CITY OF PORTLAND, MAINE

Project Name: Luminato
Address: 169 Newbury Street
Applicant: Luminato Condominium, LLC
Planner: Caitlin Cameron

Project ID: 2016-021
CBL: 028 I9 and 028 I10

PLANNING BOARD REPORT PORTLAND, MAINE

Figure 3

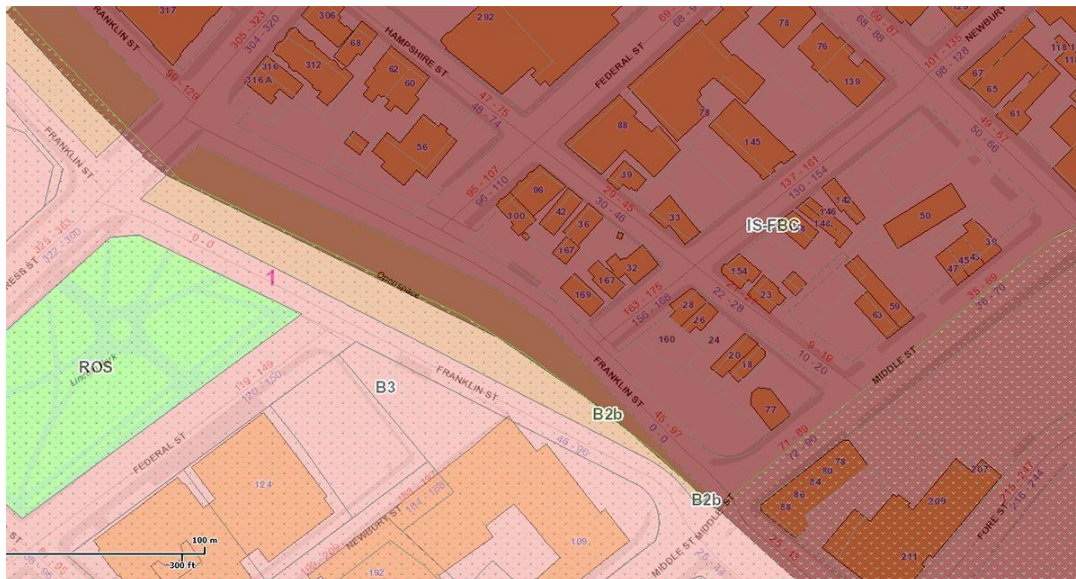
No potential wetlands within the proposed subdivision (*Figure 3*).

No river, stream or brook within or abutting the proposed subdivision (*Figure 3*).
